<b>Settlement</b>	<b>Aberlour</b>
<b>Site Address</b>	Braes of Allachie
<b>Ref Number</b>	R5, R2A
<b>Bid Summary</b>	Allocation of an additional two sites at Braes of Allachie. Site A for 50 houses and Site B for 2 houses.
<b>Site Description</b>	Site A is an irregular shaped site of 3.19 ha on the slopes of the Braes of Allachie. The land is characterised as rough agricultural/ grazing land. Site B is a small almost rectangular piece of ground immediately adjacent to the existing R2 designation and is a relatively flat area of agricultural grazing ground. Access to both sites is proposed directly off the public road.
<b>Greenfield/ Brownfield</b>	Greenfield
<b>Current Zoning</b>	Countryside

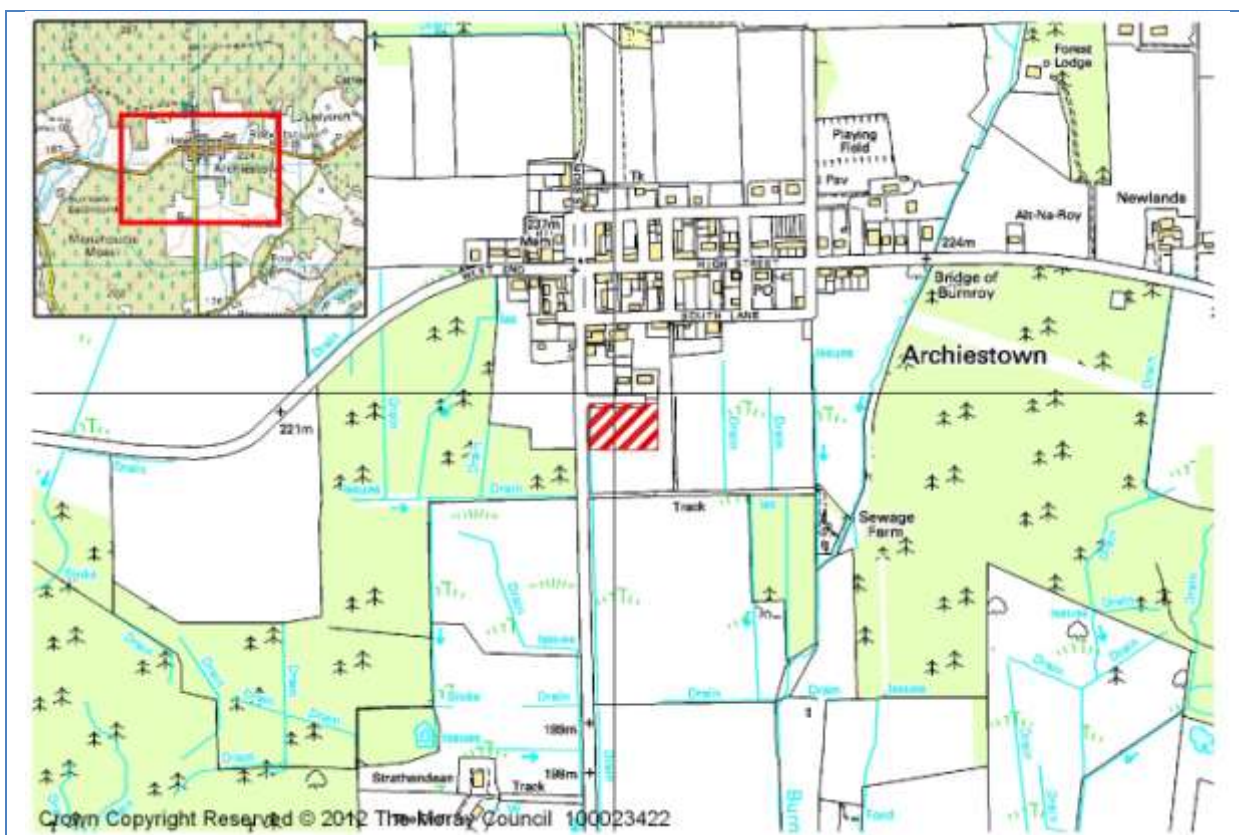
<b>Transportation</b>	Footway connections required northwards from site to the Square. Visibility splays may require third party land, minimum required 2.4m X 70m to north, 2.4m X160 m to south.
<b>Planning History</b>	No recent planning history on site.
<b>Environmental Health</b>	No comments raised in terms of noise or contaminated land.
<b>Flooding</b>	The site is not shown as flooding on the SEPA indicative flood maps.

<b>Landscape</b>	The site is relatively flat and sits slightly higher than surrounding land. There are no natural features on site to assist the development to blend in however, it will be viewed in the context of the village townscape. Landscaping is suggested to reduce the impact from the south approaching from the Carron direction.
<b>Biodiversity/Natura</b>	Drainage issues will be a relevant consideration. The sites could include wet ground and problems with ground and surface water. Nearby ditches do drain to the River Spey SAC so it will be important to ensure that measures can be taken to ensure water quality is not affected downstream.
<b>Water/Waste water</b>	Water supply Badentinan – indicative capacity 74 units. Waste water treatment Archiestown indicative capacity 28 units.
<b>Cultural Heritage</b>	The site is in close proximity to the Archiestown conservation area. There is reference within the settlement text to incorporating lanes into development and retaining the traditional grid pattern. There are no known archaeological sites within the identified site. No archaeological mitigation would be required for this site.

<b>Overall SEA Assessment</b>	No issues raised that are considered to have a significant environmental impact.
<b>Overall Planning Assessment</b>	The site provides a logical extension to Archiestown that respects the traditional grid layout of the village. The site offers additional choice within the village with the advantage of direct access onto the public road for a small scale well designed development.
<b>Other</b>	Energy is an important consideration for areas off the mains gas supply network. The layout and orientation and design of the development should maximise the opportunities for passive solar gain and the installation of renewable technologies.

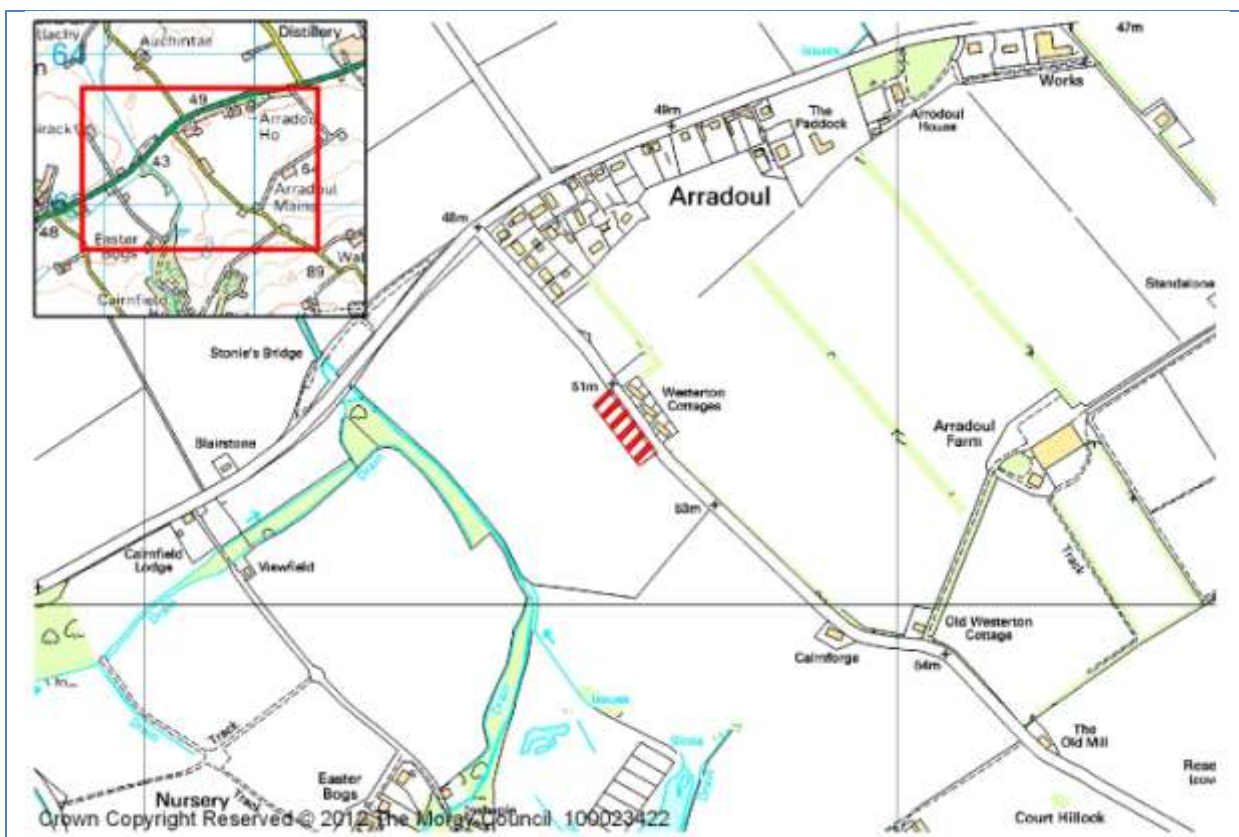
<b>Transportation</b>	The required footway provision needs third part land to connect into existing provision, road widening/passing also requires third party land.
<b>Planning History</b>	11/00672/PPP – Erect two dwellinghouses. Refused on following grounds. The resultant build-up of development located outwith and opposite an existing group of properties would lead to a suburban form of development that would detract from the character and appearance of the surrounding area. This site has an open setting with no existing natural backdrop or means of enclosure that would result in an overtly prominent development detrimental to the rural character of the surrounding area. These

<b>Landscape</b>	The site is relatively flat and sited immediately opposite and existing row of semi detached cottages. The site is bounded by post and wire fencing but lacks existing landscape features or landscape cover that would allow the development to integrate sensitively into its setting.
<b>Biodiversity/Natura</b>	SNH has made no comment.
<b>Water/Waste water</b>	SEPA - no public sewer in the area. Effluent disposal for multi-house developments will require considerable investigative work. Scottish Water – water supply Turriff 275/WWT Arradoul <10. There is limited WWTW, Scottish Water to be contacted regarding options and growth requirements. Developer advised to contact Scottish Water as WWTW outfall runs right through the proposed site.
<b>Cultural Heritage</b>	No archaeological mitigation would be required within this bid site.
<b>Overall SEA Assessment</b>	No significant environmental impact identified.

<p><b>Overall Planning Assessment</b></p>	<p>Development in Arradoul is constrained by access and drainage issues which would require to be resolved prior to any site being taken forward. Drainage issues in particular require significant investigative work. There are a number of bid sites proposed in the vicinity of Arradoul. The simplest means of designating housing land would be to extend the Arradoul rural community boundary. This proposal introduces development on the opposite side of the road from Westerton Cottages and Arradoul itself. Although adjacent to existing dwellings the housing is a significant distance from the rural community boundary and considered detached from it in relation to other bids submitted. Development in this location may be constrained by the requirements for third party land to provide the required road improvements.</p>
<p><b>Other</b></p>	<p>The proposal lies within proximity of a high pressure gas pipeline, which may affect the extent of development that can be considered. The site layout and orientation should be designed to maximise opportunities for passive solar gain and the installation of renewables.</p>

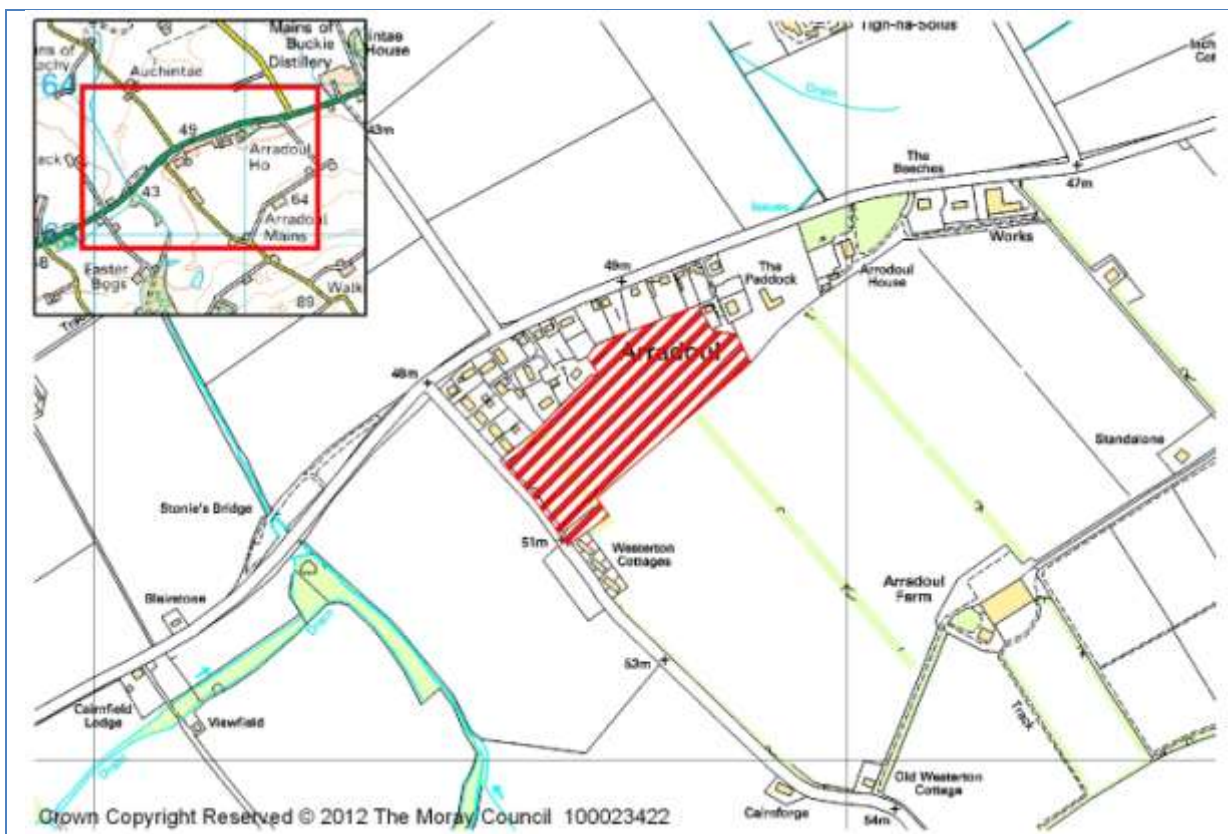
<b>Transportation</b>	Visibility splays and access could be achieved, but required road widening and footway provision need third party land to connect into existing widening and footway to northwest and southeast of the site.
<b>Planning History</b>	Planning Application of Interest 08/01468/FUL – Erect dwelling approved. No objection by roads as not proposing an additional access onto A98. Poor ground

conditions overcome by the submission of engineer's porosity test.
<b>Environmental Health</b>	No comments have been raised in terms of noise and contaminated land issues.
<b>Flooding</b>	SEPA - Problems have been reported in the past with run-off from adjacent land affecting houses in Arradoul. A drainage plan will be needed to ensure this is dealt with appropriately and does not increase the risk of flooding elsewhere. Flood Team – No known fluvial flood risk, however there is a problem with surface water flooding in the field which threatens the existing properties. The developer should mitigate any adverse effects so as to not increase flood risk to existing properties. A Flood Risk Assessment may be required. The proposals suggest using an existing SUDS system the developer would need to provide evidence that the existing system had enough capacity for this increase.
<b>Landscape</b>	The site is relatively flat and contained by housing to the north. The existing stand of trees on site should be retained and additional planting to the southern boundary would be sought to assist the development in integrating sensitively.

<b>Biodiversity/Natura</b>	There are existing stands of trees on the site that if retained there would be no survey requirements
<b>Water/Waste water</b>	No public sewers in the area. Effluent disposal from multi-house developments will require considerable investigative work. Scottish Water - water supply Turriff 275/ WWT private.
<b>Cultural Heritage</b>	Taking into consideration the site of a now demolished prehistoric stone circle to the north of this area, there is potential for archaeological remains within this bid site. Therefore an archaeological watching-brief would be required within this bid site prior to/at the outset of development commencing
<b>Overall SEA Assessment</b>	No significant environmental impact identified.
<b>Overall Planning Assessment</b>	Development in Arradoul is constrained by access and drainage issues which would require to be resolved prior to any site being taken forward. Drainage issues in particular require significant investigative work. There are a number of bid sites proposed in the vicinity of Arradoul. The simplest means of designating housing land would be to extend the Arradoul rural community boundary. This proposal is for an additional 17 dwellings immediately to the south of the community, which would result in a significant addition to Arradoul. Development of the site would also introduce housing at the rear of existing properties fronting onto the A98. This is reflective of the character of the western end of the rural community where there have been a number of plot subdivisions. This would result in a settlement pattern that does not perpetuate the linear development of Arradoul along the roadside. Given the scale of development proposed consideration should be given to a phased development. Development may be

constrained by the requirements for third party land to provide adequate visibility splays.
<b>Other</b>	The site layout and orientation should be designed to maximise the opportunities for solar passive gain and installation of renewable technologies.

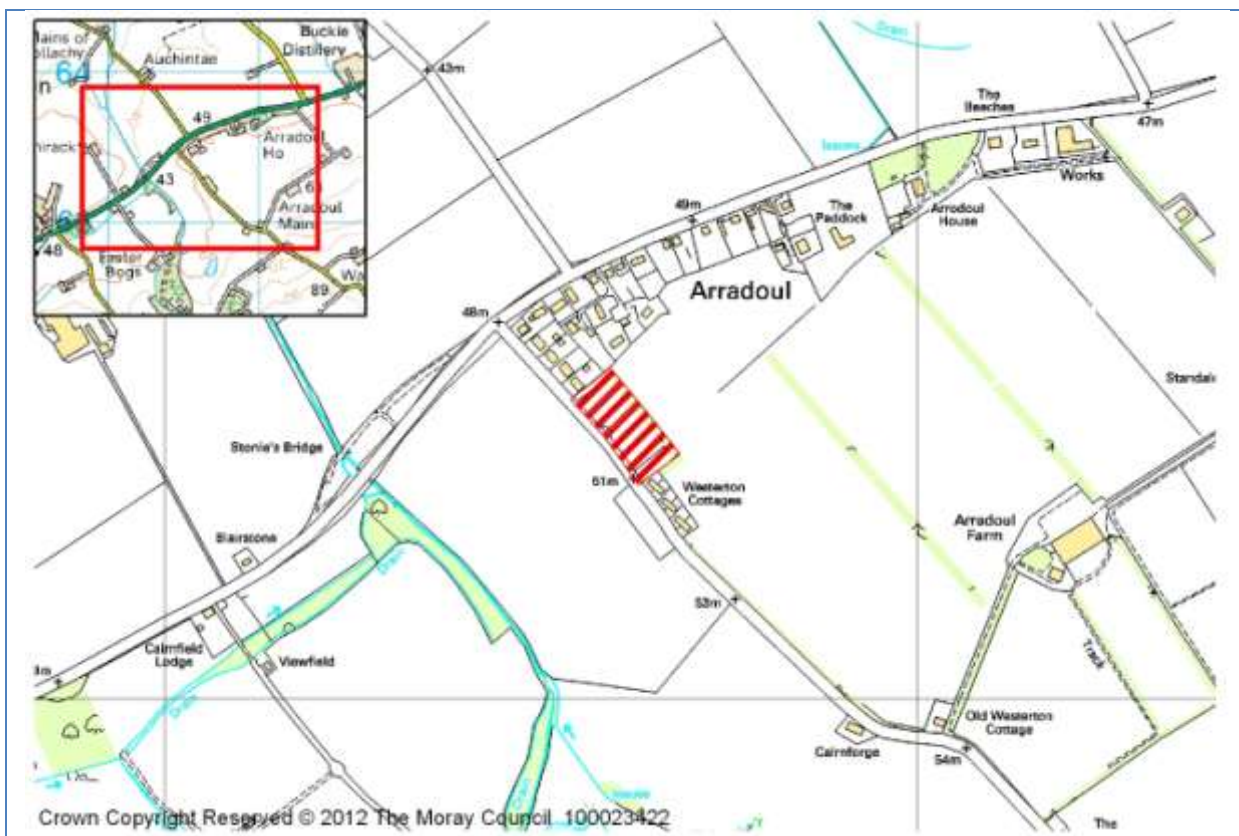
<b>Transportation</b>	Visibility splays and access could be achieved but requires road widening and footway provision needs third party land to connect into existing widening and footway to northwest and southeast of the site.
<b>Planning History</b>	Planning Application of Interest 08/01468/FUL – Erect dwelling approved. No objection by roads as not proposing an additional access onto A98. Poor ground conditions overcome by the submission of engineer's porosity test.
<b>Environmental Health</b>	No comments raised in terms of noise or contaminated land issues.

<b>Flooding</b>	SEPA - Problems have been reported in the past with run-off from adjacent land affecting houses in Arradoul. A drainage plan will be needed to ensure this is dealt with appropriately and does not increase the risk of flooding elsewhere. Flood Team – No known fluvial flood risk, however there is a problem with surface water flooding in the field which threatens the existing properties. The developer should mitigate any adverse effects so as to not increase flood risk to existing properties. A Flood Risk Assessment may be required. The proposals suggest using an existing SUDS system the developer would need to provide evidence that the existing system had enough capacity for this increase.
<b>Landscape</b>	The site is flat and well contained by housing at each side and a stand of trees to provide a backdrop.
<b>Biodiversity/Natura</b>	There are existing stands of trees on site that if retained there would be no survey requirements.

<b>Water/Waste water</b>	No public sewers in the area. Effluent disposal from multi-house developments will require significant investigative work. Scottish Water - water supply Turriff 275/ WWT private.
<b>Cultural Heritage</b>	Taking into consideration the site of a now demolished prehistoric stone circle to the north of this area, there is potential for archaeological remains within this bid site. Therefore an archaeological watching-brief would be required within this bid site prior to/at the outset of development commencing.
<b>Overall SEA Assessment</b>	No significant environmental impact identified.
<b>Overall Planning Assessment</b>	Development in Arradoul is constrained by access and drainage issues which would require to be resolved prior to any site being taken forward. Drainage issues in particular require significant investigative work. There are a number of bid sites proposed in the vicinity of Arradoul. The simplest means of designating housing land would be to extend the Arradoul rural community boundary. This proposal would fill in the gap site between Arradoul and Westerton Cottages and include them within the rural community boundary. This type of extension would perpetuate and emphasize the linear development of Arradoul along the roadside. This may be acceptable on the basis that future development within Arradoul would consolidate the rural community by concentrating development in the land to the rear of this site if it is proven viable to do so. Development may be constrained by the requirement for third party land to achieve adequate visibility splays.

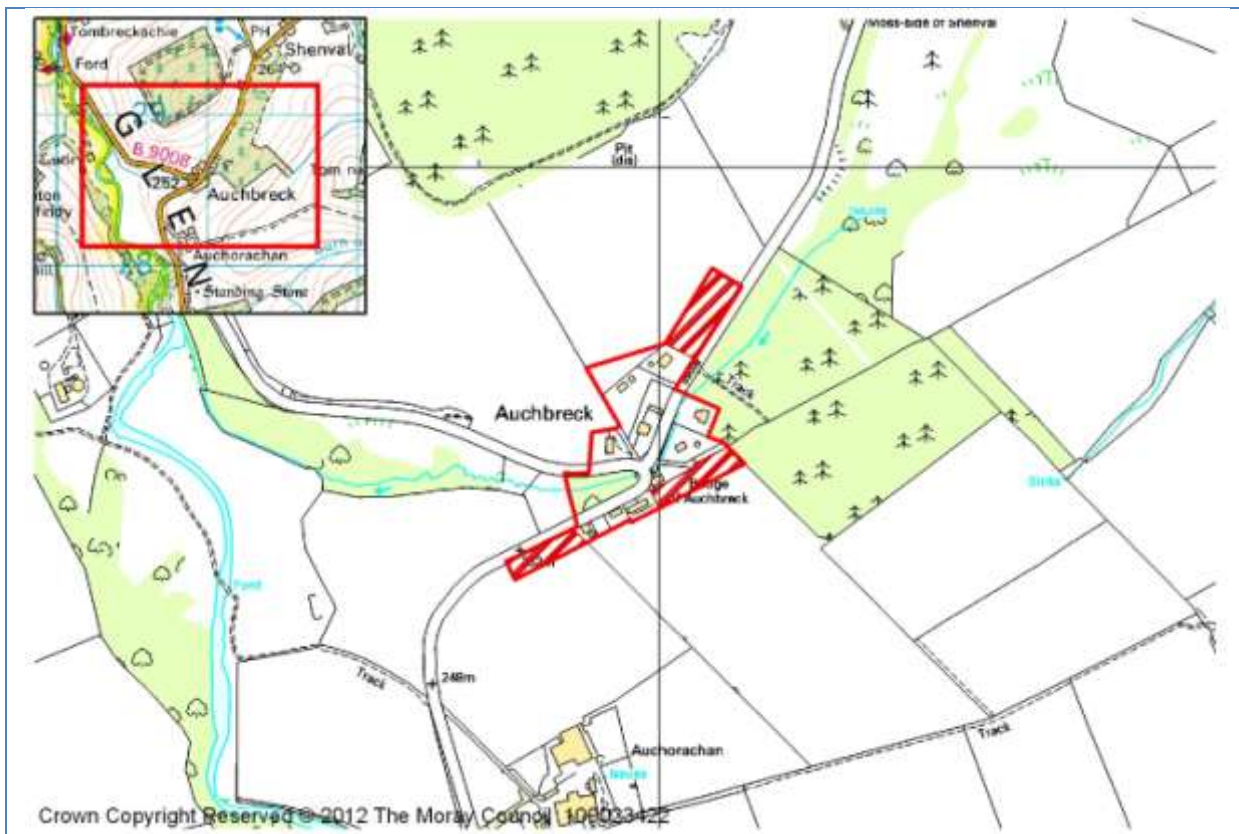
(constructed)
<b>Environmental Health</b>	No comments raised in terms of contaminated land and noise issues.
<b>Flooding</b>	SEPA has raised no issues in terms of flooding and the site is not shown as flooding on the SEPA indicative flood maps. Flood Team – no known fluvial flooding at this location.
<b>Landscape</b>	Site C is located on the south western edge of Auchbreck. The site is on land that rises up gently from the roadside, there are no natural features to assist the development to integrate sensitively. Site D is located on the north eastern edge of Auchbreck and sits higher than the public road, the hill behind the site provides a backdrop. Given the agricultural nature of the development there is no landscape coverage to soften the development.
<b>Biodiversity/Natura</b>	The burn that runs through Auchbreck flows swiftly into the River Livet, a tributary of the River Spey and part of the SAC. Any development in Auchbreck needs to demonstrate, at the application stage, how the existing watercourses will be protected during construction.

<b>Water/Waste water</b>	Scottish Water – water supply Tomnavoulin indicative housing capacity less than 10 units. Waste water treatment private. SEPA no public sewers in the area. Effluent disposal from multi-house developments will require considerable investigative work. The current local plan makes reference to ground conditions.
<b>Cultural Heritage</b>	Site B - No archaeological mitigation would be required within this bid site. Site C – Taking into consideration the topography of the land and an enclosure of unknown date to the NW of this area (SMR Ref NJ22NW0037), there is potential for archaeological remains here. Therefore an archaeological watching-brief would be required within this bid site prior to/at the outset of development commencing. Site D - No archaeological mitigation would be required within this bid site.
<b>Overall SEA Assessment</b>	No significant environmental impact identified.

<b>Overall Planning Assessment</b>	Both bid sites would extend Auchbreck in a linear fashion. Previous bid sites have consolidated the core of the community around the former church and manse. The proposals would lead to a strung out settlement pattern that would have an adverse impact on the character and appearance of the community. Site B remains undeveloped and there is scope of three dwellings and therefore still an opportunity for growth in Auchbreck.
<b>Other</b>	The site layout and orientation should be designed to maximise the opportunities for passive solar gain and installation of renewable technologies.

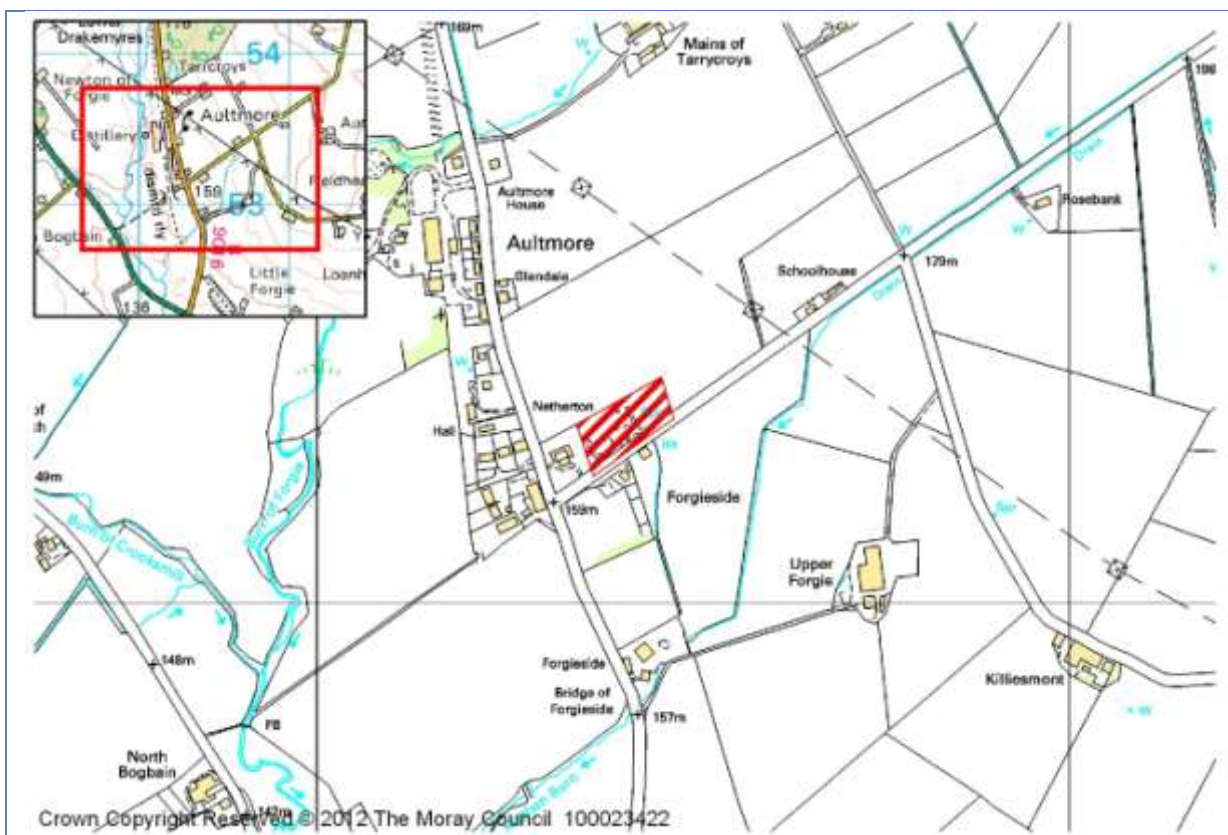
<b>Landscape</b>	<p>The proposed site is well-contained within the landscape being bounded by trees and vegetation to the north, south, east and west. The land rises slightly up towards the east. The site is currently accessed via a vehicular gate on the southern boundary. There are existing residential properties to the south of the site. The site is not visible from the main thoroughfare through Aultmore.</p>
<b>Biodiversity/Natura</b>	<p>SNH has provided the following comments on protected species:</p> <ul style="list-style-type: none"> <li>• If existing buildings are to be demolished or altered then a bat survey is likely to be necessary.</li> </ul>
<b>Water/Waste water</b>	<p>Site A would be served by Herricks Water Treatment Works (WTW) which has a capacity of 198 units. Waste water would require to be disposed of via private septic tanks.</p>
<b>Cultural Heritage</b>	<p>No archaeological mitigation would be required within this bid site. No cultural heritage assets would be affected by the development of this site.</p>

<b>Overall SEA Assessment</b>	<p>There is drainage issues associated with development in Aultmore and a spring within the site. A bat survey will be necessary should the existing buildings be demolished or altered.</p>

<b>Overall Planning Assessment</b>	Although not included within the existing rural community boundary the site is in use as a plant nursery and is well-contained within the landscape. Whilst the general pattern of development has taken place along the main thoroughfare there are a number of houses immediately adjacent the site. Given the proposal would constitute re-using a brownfield site and for the reasons cited above, it is intended to support the development providing satisfactory access arrangements can be achieved.
<b>Other</b>	The site is located within Newmill Primary and Keith Grammar School catchments.
